Access Compliance Report Public Rights-of-Way (Curb Ramps)

Main Street: RANCHWOOD_RD Cross Street: TRAILS_END_LN Location: NW

ADA ID: RPRK211006113702 Ramp Type: Type 1 - Perpendicular Diagonal Initial Pass/Fail: Fail Overall Compliance: No Severity Score: 45

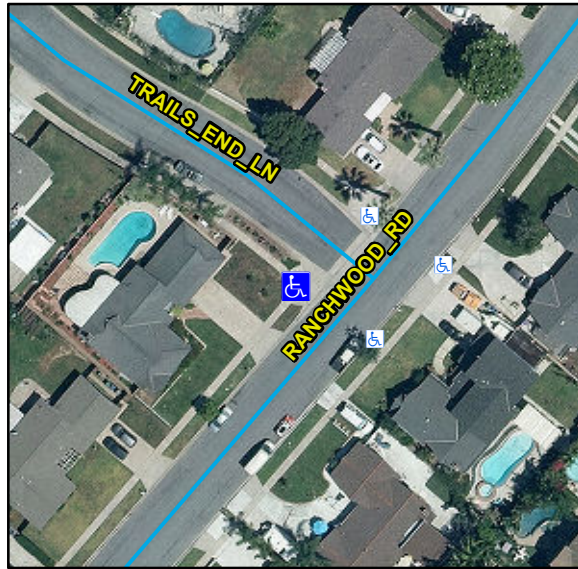
Remove & Replace Curb Ramp With Two New Directional Ramps or Equivalent.

R304.2.2, R204.3, R304.5.3, R302.7.2, STD 1115
